**CITY OF TEMPE  
DEVELOPMENT REVIEW COMMISSION**

Meeting Date: 30/22/2016  
Agenda Item: 4

**ACTION:** Request for a Development Plan Review for a new 219,212 s.f. office building for THE GRAND AT PAPAGO PARK CENTER – PHASE 1, located at 1151 West Washington Street. The applicant is Lincoln Property Company.

HKS PROJECT NUMBER: 17441.000  
 DATE: 01/26/16  
 ISSUE: DEVELOPMENT APPLICATION  
 SHEET TITLE: PRELIMINARY LANDSCAPE PLAN  
 SHEET NO. LS.01

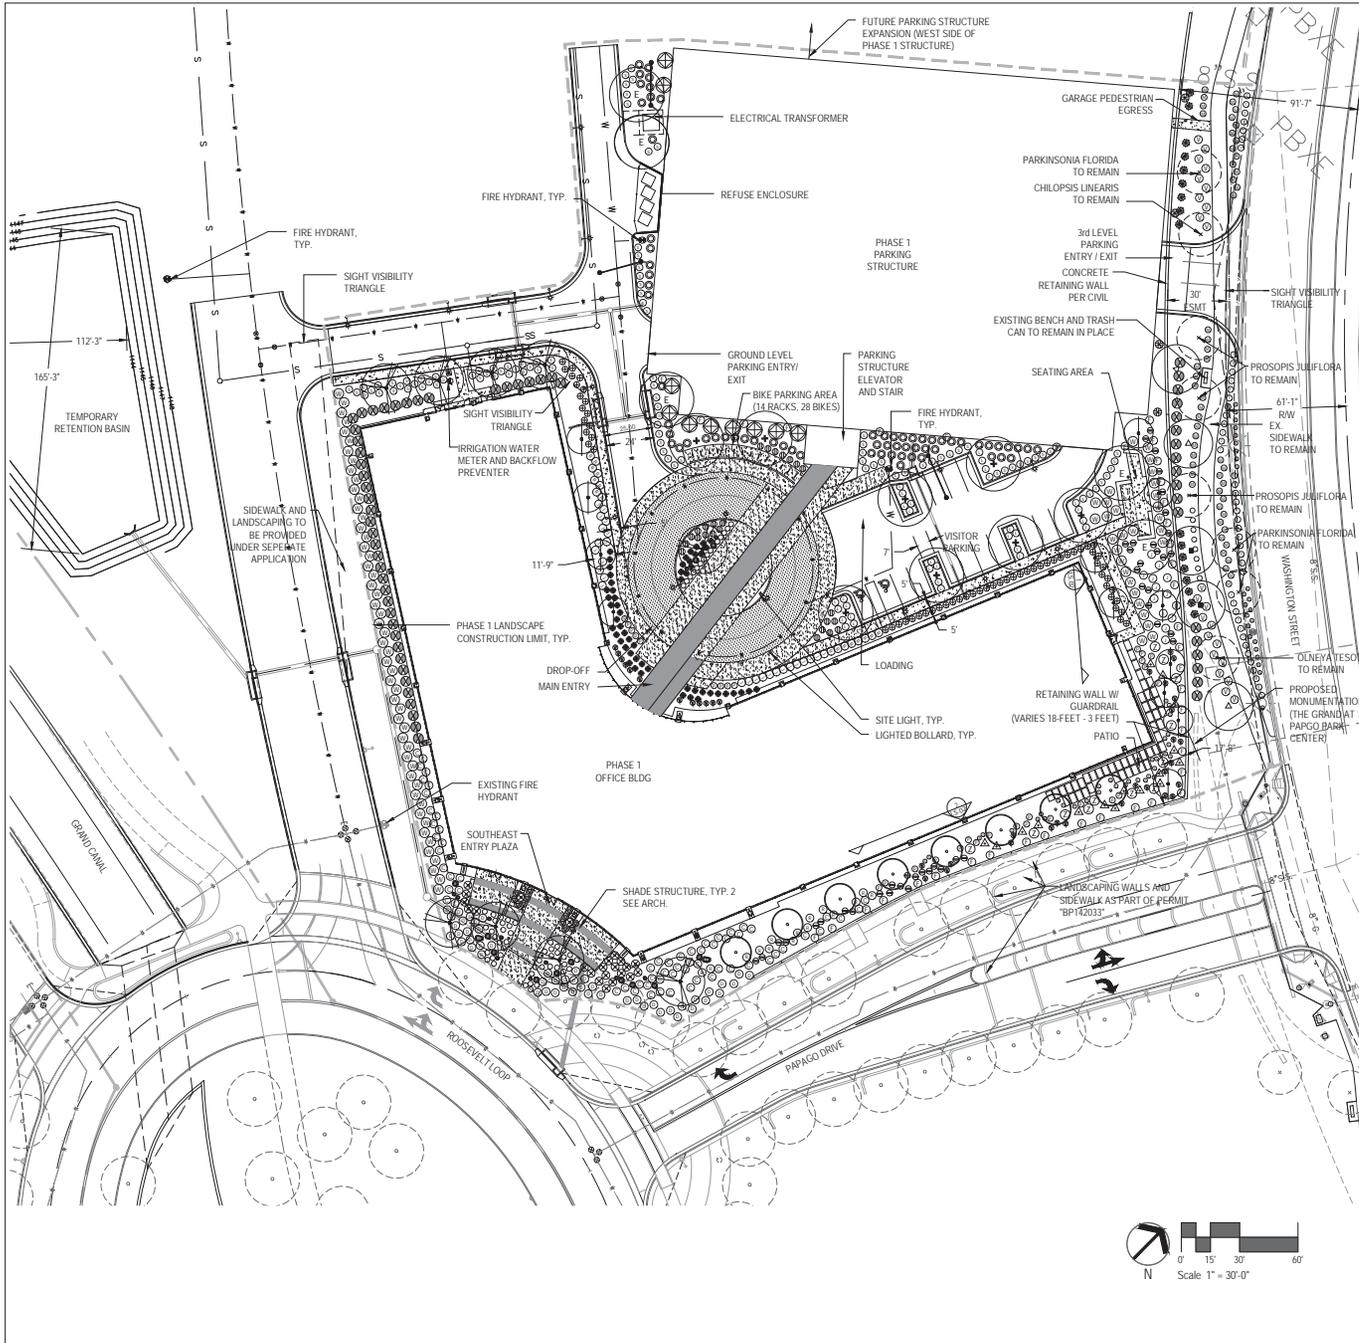
21. Arterial street trees shall be a minimum of 36" box specimens and a minimum of 1 ½" caliper trunk.
22. Irrigation notes:
  - a. Provide dedicated landscape water meter.

- b. Provide pipe distribution system of buried rigid (polyvinylchloride), not flexible (polyethylene). Use of schedule 40 PVC mainline and class 315 PVC ½" feeder line is acceptable. Class 200 PVC feeder line may be used for sizes greater than ½". Provide details of water distribution system.

24. Top dress planting areas with a rock or decomposed granite application. Provide rock or decomposed granite of 2" uniform thickness. Provide pre-emergence weed control application and do not underlay rock or decomposed granite application with plastic.

25. Trees shall be planted a minimum of 20'-0" from any existing or proposed public water or sewer lines. The tree planting separation requirements may be reduced from the waterline upon the installation of a linear root barrier, a minimum of 6'-0" parallel from the waterline, or around the tree. The root barrier shall be a continuous material, a minimum of 0.08" thick, installed 0'-2" above finish grade to a depth of 8'-0" below grade. Final approval subject to determination by the Public Works, Water Utilities Division.

BUILDING  
ELEVATIONS  
SHEET NO.

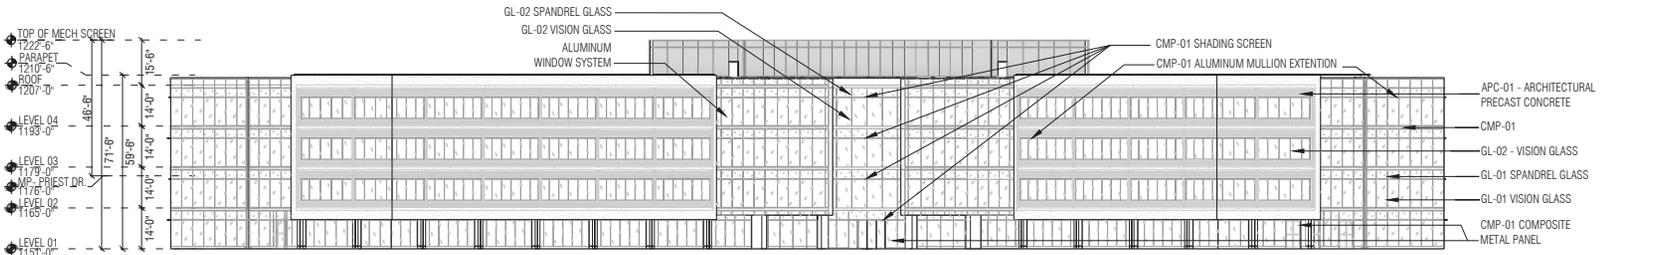
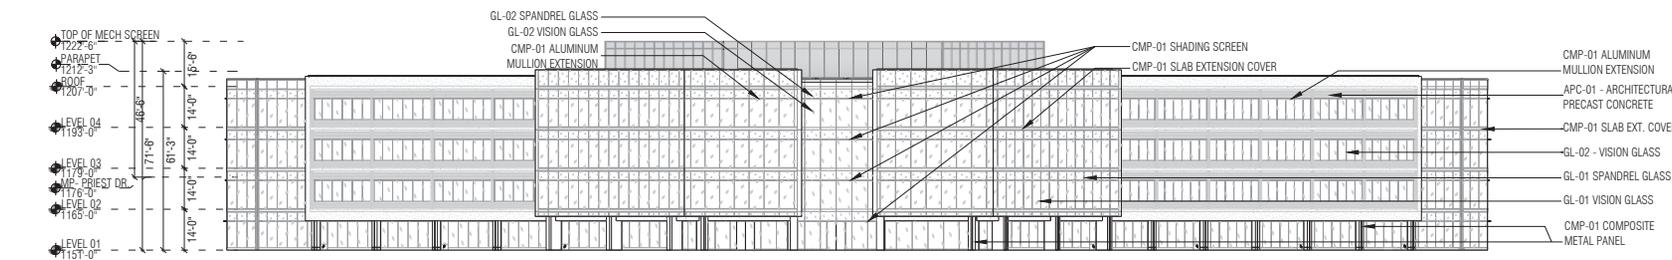
14. The materials and colors are approved as presented:
  - Architectural precast concrete – Coreslab – sandblasted finish
  - Vision and spandrel insulated glass – Viracon – 1" insulated Graphite Blue and Clear
  - Composite metal panels at building wall and rooftop mechanical screening – Alucobond
  - Perforated metal panels at garage – Kal Zip

15. Provide secure roof access from the interior of the building. Do not expose roof access to public view.
16. Conceal roof drainage system within the interior of the building.
17. Incorporate lighting, address signs, and incidental equipment attachments (alarm klaxons, security cameras, etc.) where exposed into the design of the building elevations. Exposed conduit, piping, or related materials is not permitted.
18. Locate the electrical service entrance section (S.E.S.) inside the building or inside a secure yard that is concealed from public view.
19. Upper/lower divided glazing panels in exterior windows at grade level, where lower glass panes are part of a divided pane glass curtain-wall system, shall be permitted only if laminated glazing at these locations is provided.
